AGENDA

CITY OF NORMAN, OK
HISTORIC DISTRICT COMMISSION MEETING
Municipal Building, Council Chambers, 201 West Gray, Norman, OK 73069
Monday, May 04, 2026 at 5:30 PM

ITEM TITLE: (HD 26-07) CONSIDERATION OF APPROVAL, REJECTION, AMENDMENT, AND/OR POSTPONEMENT OF THE CERTIFICATE OF APPROPRIATENESS REQUEST FOR THE PROPERTY LOCATED 413 S LAHOMA AVENUE FOR THE FOLLOWING MODIFICATIONS: A) CONSTRUCTION OF A DETACHED ACCESSORY DWELLING UNIT. (Postponed from the May 4, 2026, meeting).

ITEM TITLE: (HD 26-10) CONSIDERATION OF APPROVAL, REJECTION, AMENDMENT, AND/OR POSTPONEMENT OF AMENDMENTS TO CERTIFICATES OF APPROPRIATENESS 24-08 AND 25-04 FOR THE PROPERTY LOCATED AT 1320 OKLAHOMA AVENUE FOR THE FOLLOWING: A) MODIFICATIONS TO THE FRONT WALKWAY AND YARD; B) MODIFICATIONS TO THE EXTERIOR WALL MATERIALS; C) MODIFICATIONS TO THE GARAGE DOOR DESIGN; D) MODIFICATIONS TO WINDOWS. (Items A, B, and C were postponed from the April 6, 2026, meeting.)

3-Change proposed garage door design

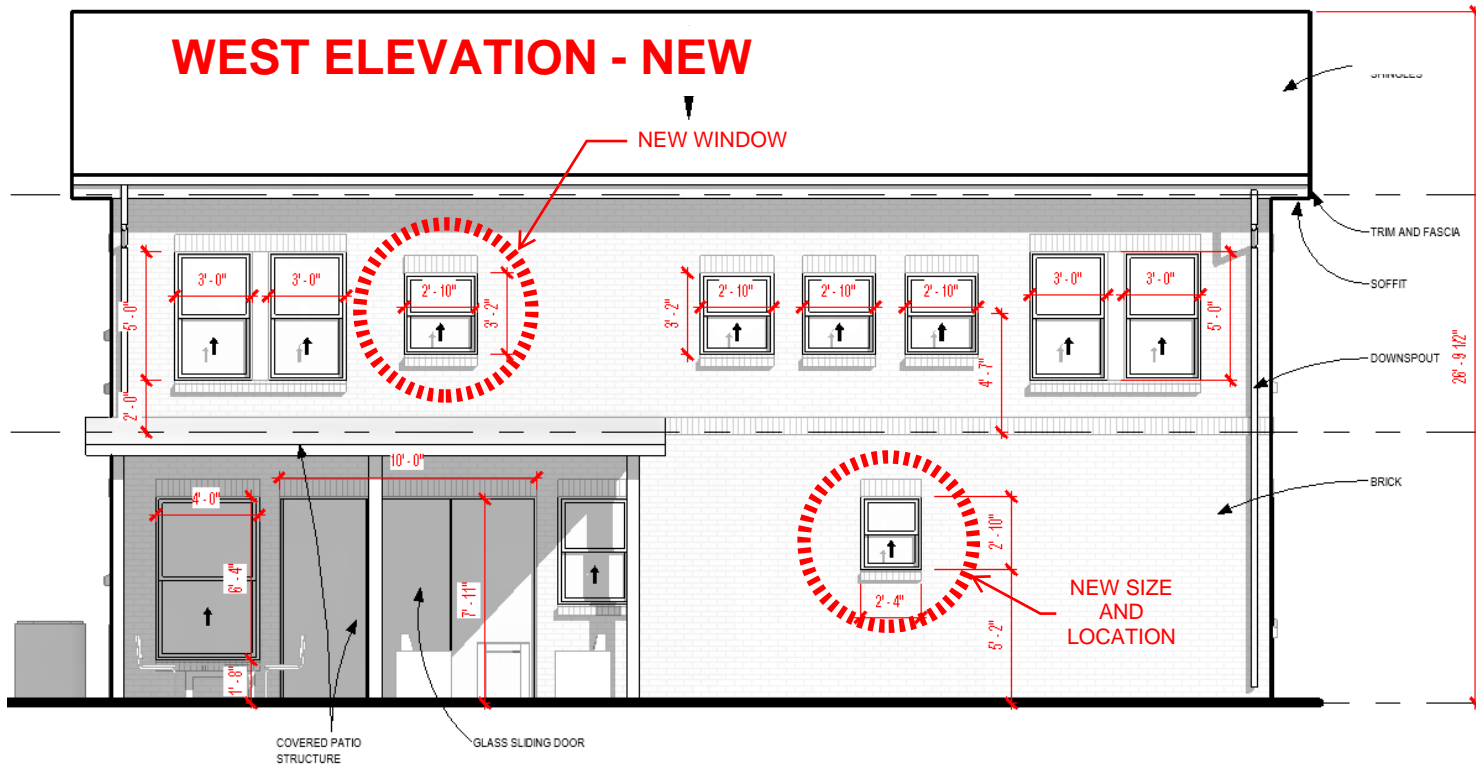
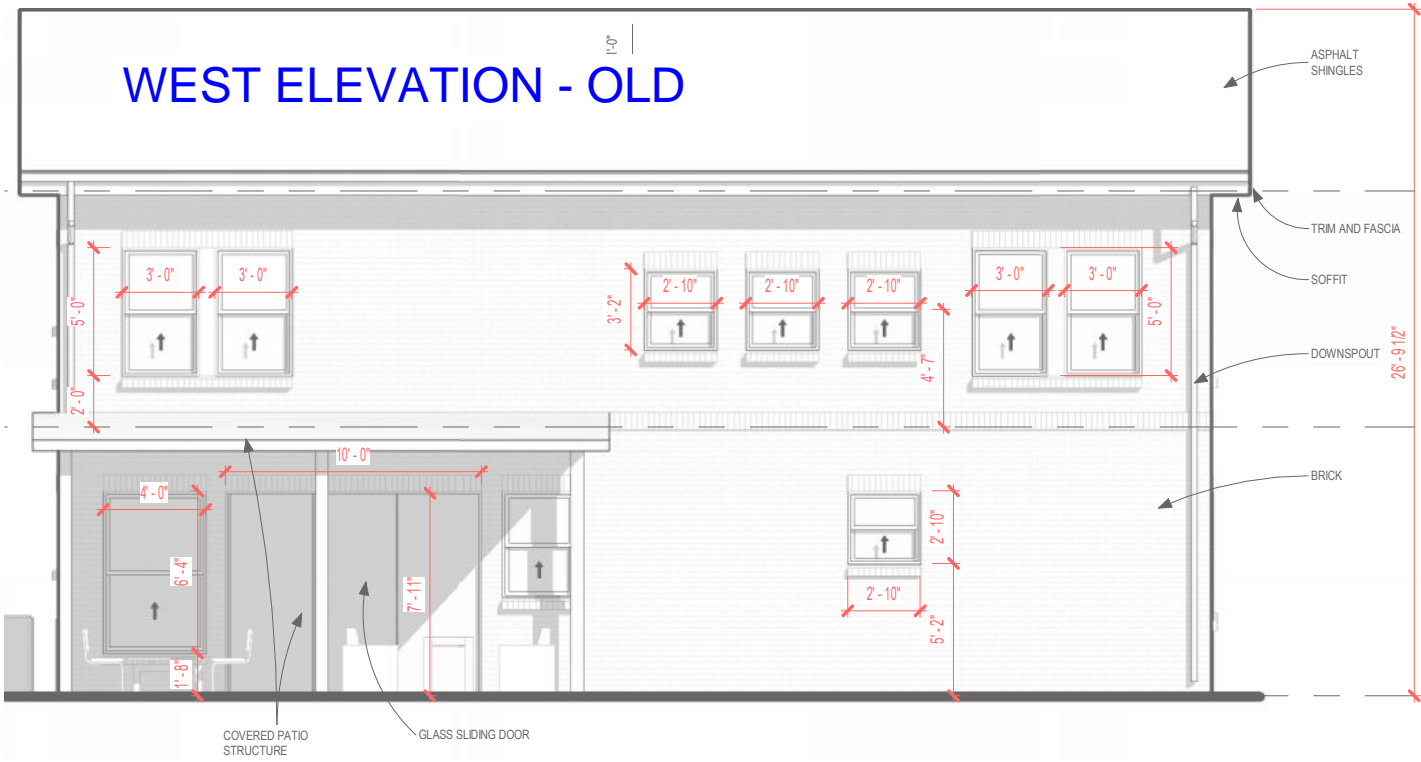
The height of the garage door and the addition of a top row of window lites are typical of a modern-day garage. The proposed modifications to the garage door are minimal and maintain the previously approved design intent.

The Commission will need to determine whether the proposed garage door modifications meet the *Preservation Guidelines* and are compatible with the Southridge District.

The applicant is requesting revisions to the previously approved garage door design. The revisions include increasing the height from 7' to 8' and adding window lites at the top of the overhead garage door. The door material remains as previously approved: a metal door with composite trim, with a design shown in the submitted drawings. The requested modification has not changed since the April 4, 2026, Historic District Commission meeting; however, the applicant has provided clearer illustrations of the proposed garage door design.

4- Modify proposed exterior window openings and placement

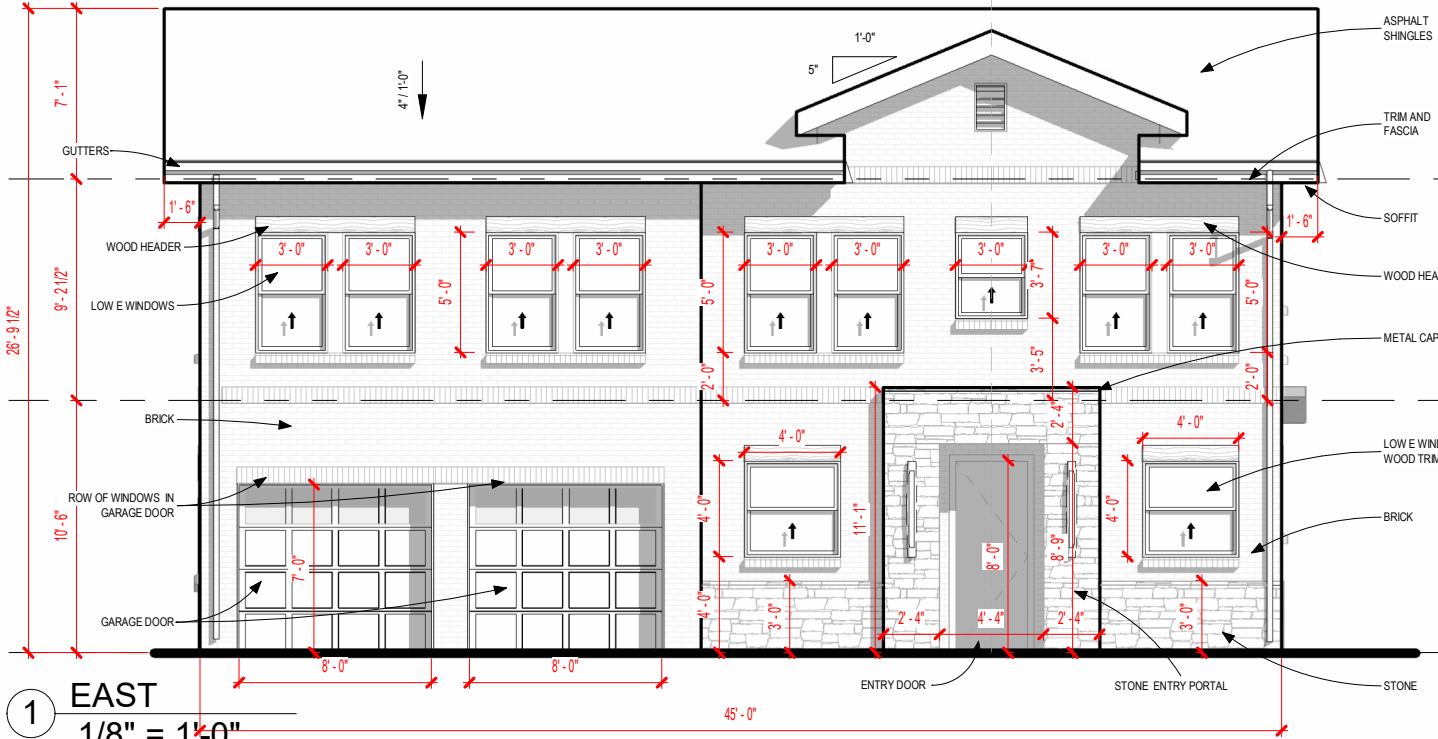
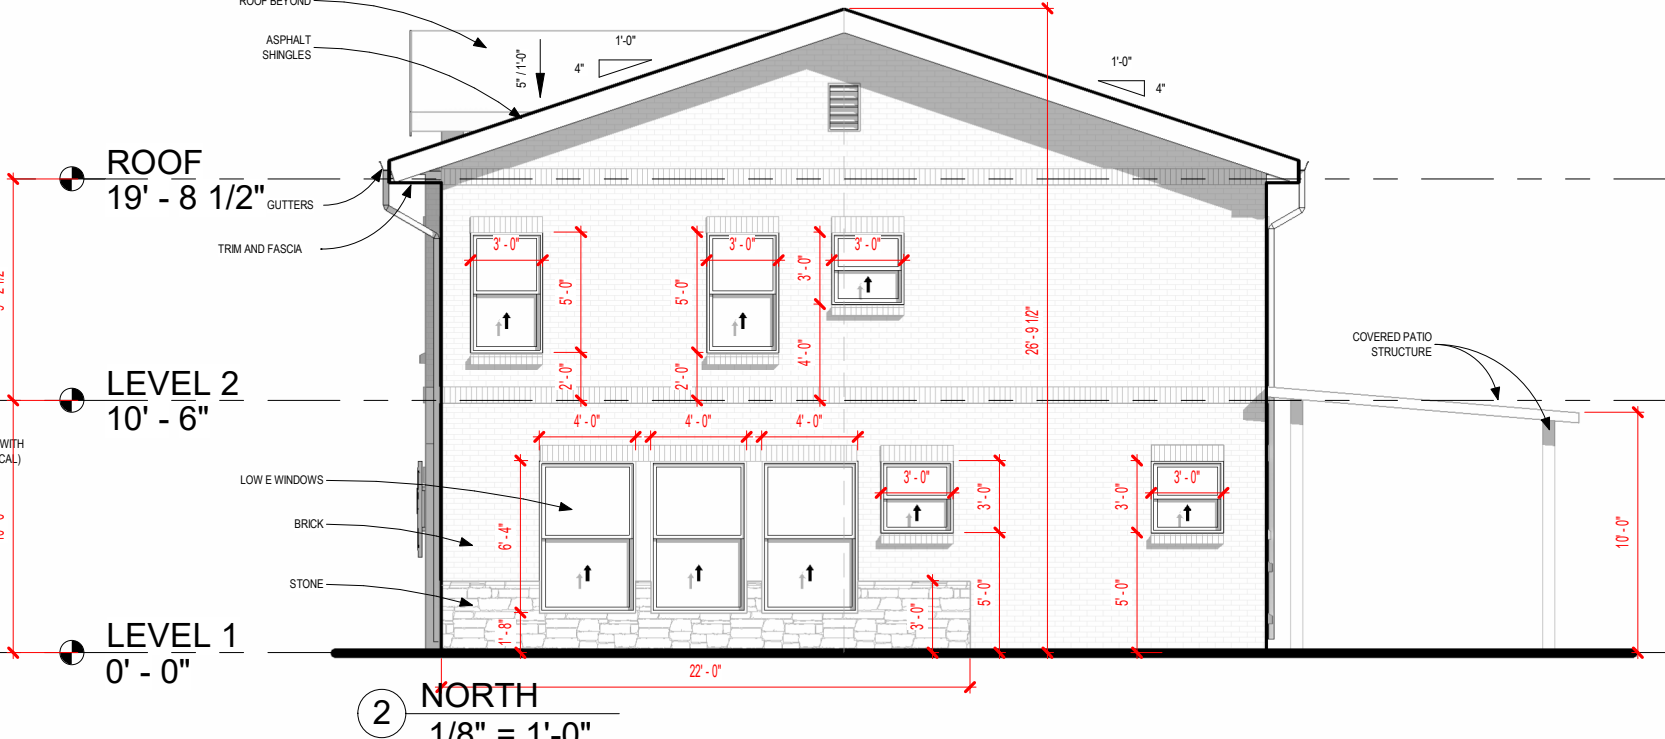
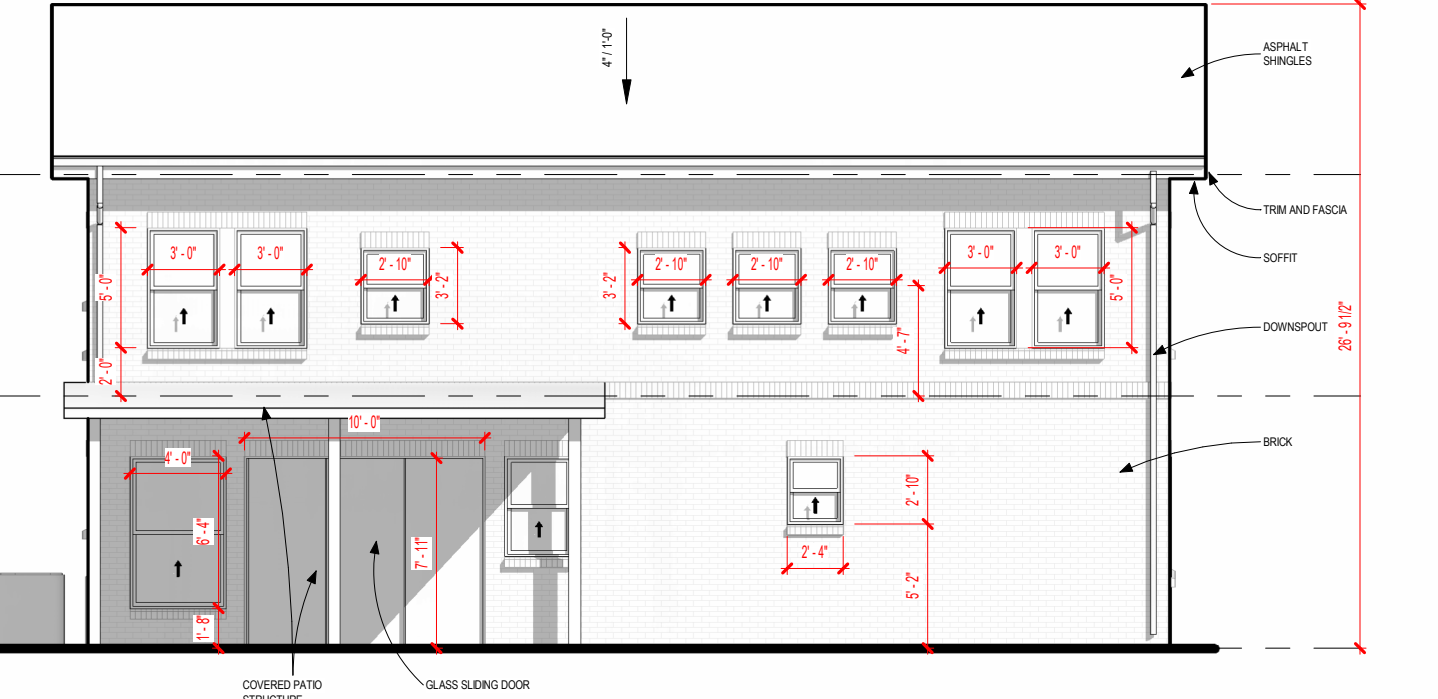
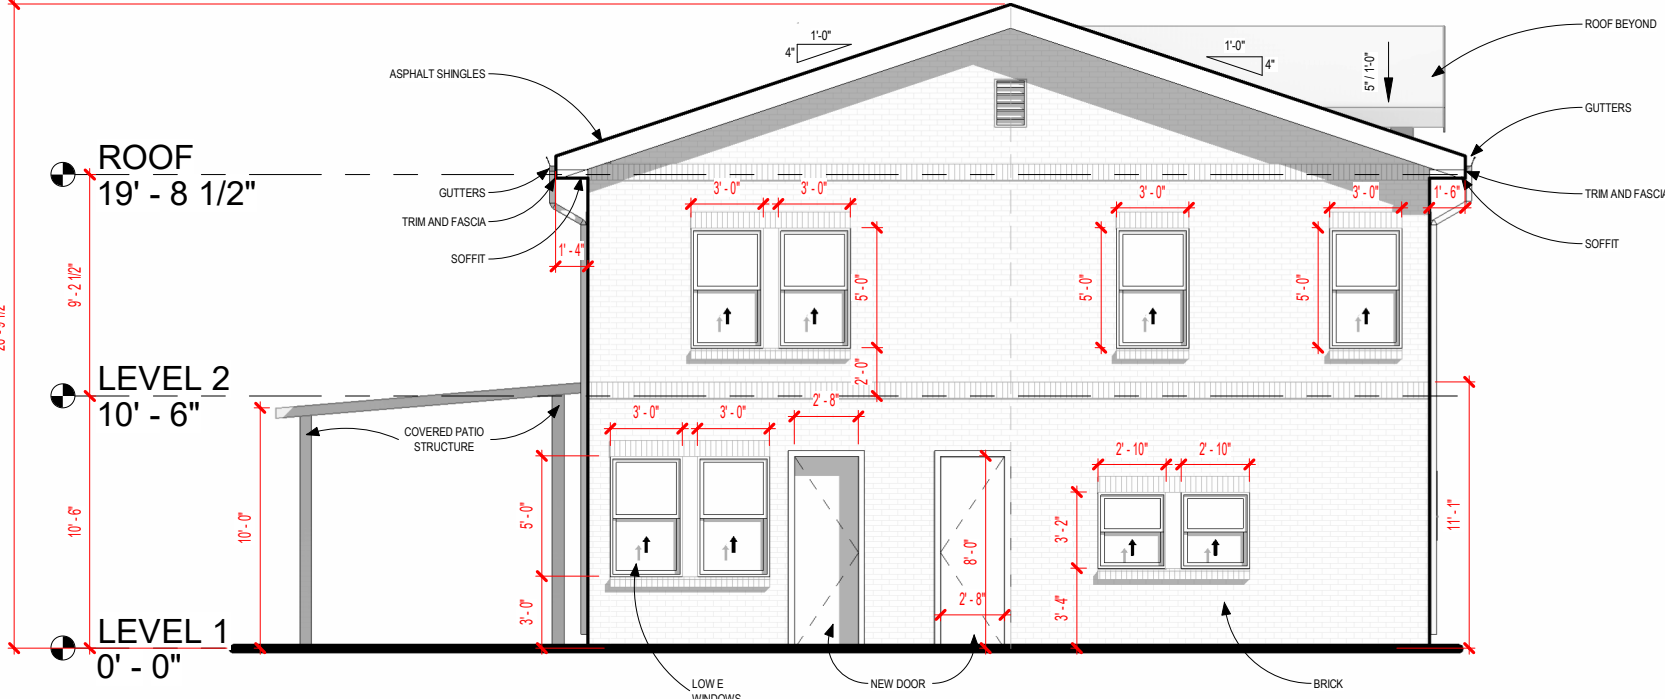
The applicant proposes the same aluminum-clad windows approved by a previous COA. The applicant is requesting minor modifications to the placement and opening sizes of the previously approved windows on this proposed structure. The requested windows are in harmony with the previously approved windows in terms of size and placement. The requested changes do not appear to significantly alter the exterior design proposed for this new structure.

The Commission will need to determine whether the proposed window modifications meet the *Preservation Guidelines* and are compatible with the Southridge District.

The applicant is requesting an amendment to the previously approved COA to allow adjustments to the windows' quantity, placement, and size to accommodate changes to the house's internal programming. The same aluminum-clad wood windows previously approved by COA in May of 2025 will be utilized. The applicant provided revised drawings showing the proposed modifications to windows on the rear of the structure. The drawing shows the addition of one window on the second floor and the modification of the size and location of another window on the first floor to accommodate internal programming.

Before

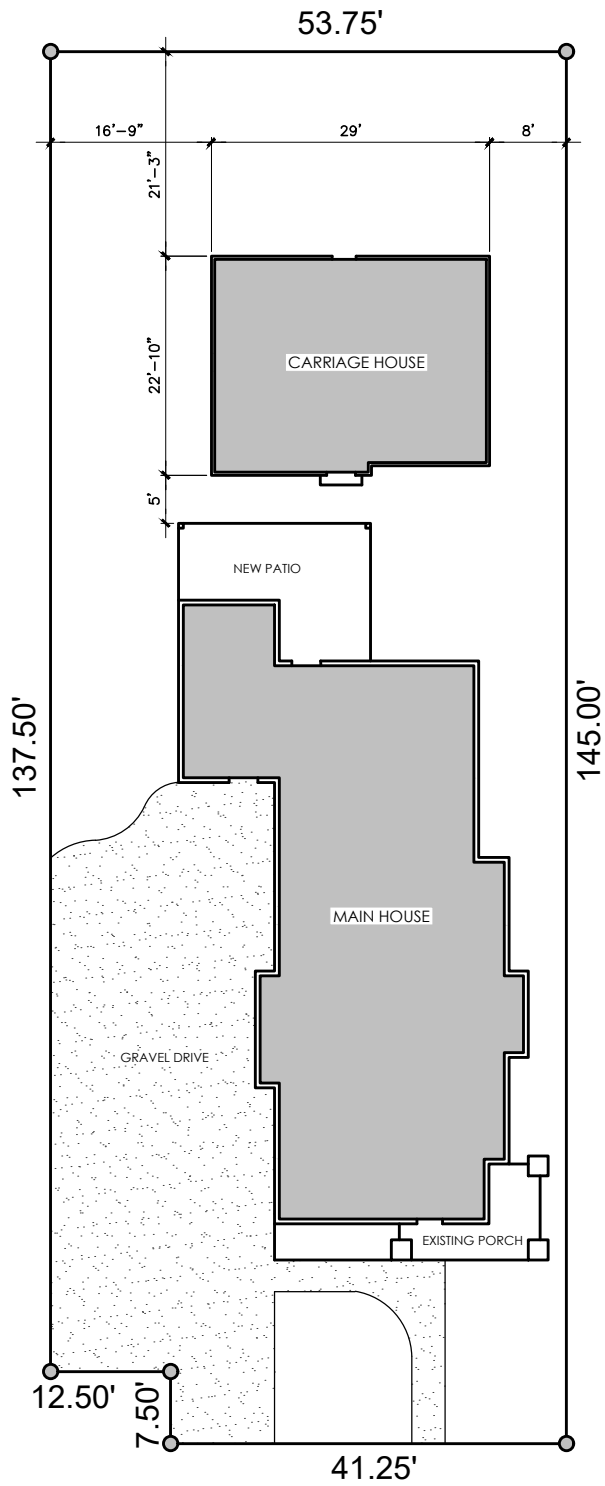
The Commission will need to determine if the requested amendment of the COA to remove a secondary door opening and replace it with wood siding meets the *Guidelines* and is compatible with the historic principal structure and the district.

The applicant received approval on August 5, 2025, to replace the entry doors on the principal structure. The applicant is now returning to the Historic District Commission with an amendment to remove the front-facing secondary door on the north side and use the original wood siding to cover the removed door opening. There are no other proposed alterations to the previously approved ADU.
